# **Intel<sup>®</sup> Mobile (0.18μ) Celeron<sup>™</sup> Processor Specification Update**

Release Date: June 2000

Order Number: 245421-005

Figure 6. BCLK Timing Waveform

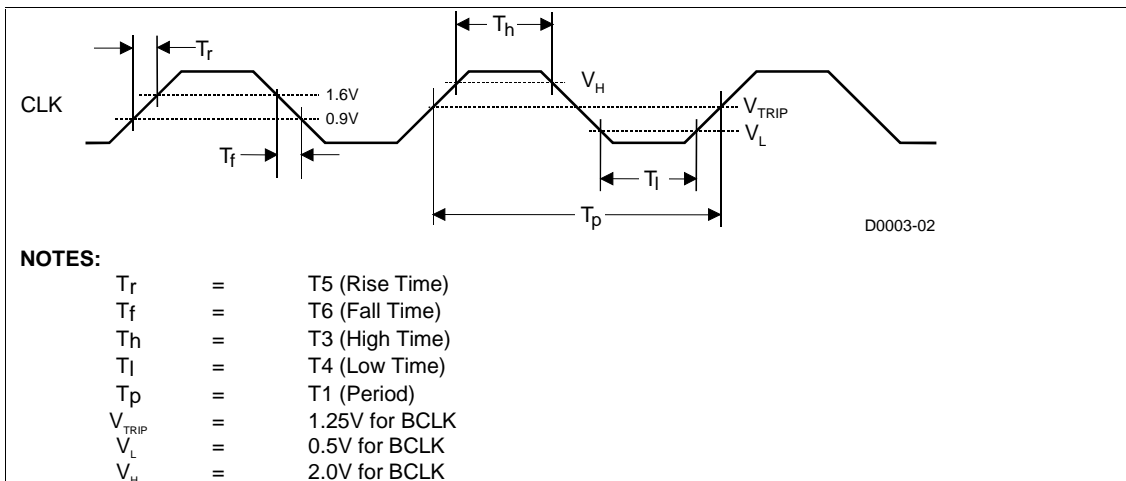
For B0 step processors, the  $V_{IH,BCLK}$  Min spec is changed to 2.0V (from 1.7V for A2 step) and  $V_{IL,BCLK}$  Max spec is changed to 0.5V (from 0.7V for A2 step). Due to this, new values are specified for BCLK high and low times for B0 step processors. These modifications affect corresponding specs in Table 12, Table 13, Table 22, and Figure 6 in *Mobile Celeron™ Processor in BGA2 and Micro-PGA2 Packages at 500 MHz, 450 MHz, and 400A MHz* datasheet.

The following tables and figures highlight the above mentioned BSEL[1:0] and BCLK specs modifications made for B0 step processors:

Symbol	Parameter	Min	Typ	Max	Unit	Figure	Notes
	System Bus Frequency		100		MHz		
T1	BCLK Period		10		ns	Figure 6	Note 2
T2	BCLK Period Stability			±250	ps		Notes 3, 4
T3	BCLK High Time	2.70			ns	Figure 6	at >2.0V
T4	BCLK Low Time	2.45			ns	Figure 6	at <0.5V
T5	BCLK Rise Time	0.175		0.875	ns	Figure 6	(0.9V – 1.6V)
T6	BCLK Fall Time	0.175		0.875	ns	Figure 6	(1.6V – 0.9V)

Figure 4. BCLK Waveform at the Processor Core Pins

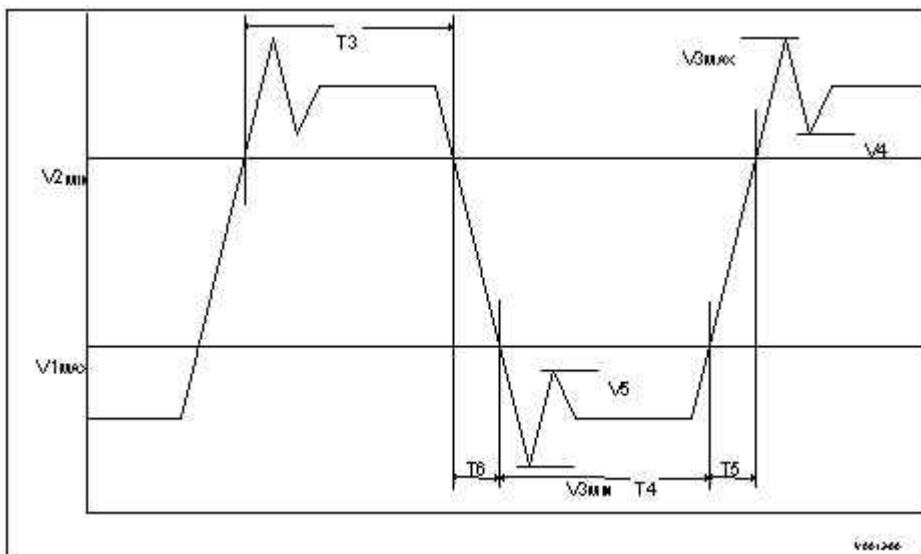
In Table 18, “BCLK Signal Quality AC Specifications at the Processor Core” of the *Intel® Celeron™ Processor Mobile Module: Mobile Module Connector 2 (MMC-2) at 500 MHz and 450 MHz Datasheet*, Note 3 has changed. Figure 4 “BCLK Waveform at the Processor Core Pins” has also been updated. See below.

- The rising edge ringback voltage specified is the minimum absolute voltage that the BCLK signal can dip back to after the BCLK signal passes the  $V_{IH,BCLK,MIN}$  (rising) voltage limits. The falling edge ringback voltage specified is the maximum absolute voltage that the BCLK signal can dip back to after the BCLK signal passes the  $V_{IL,BCLK,MAX}$  (falling) voltage limits.
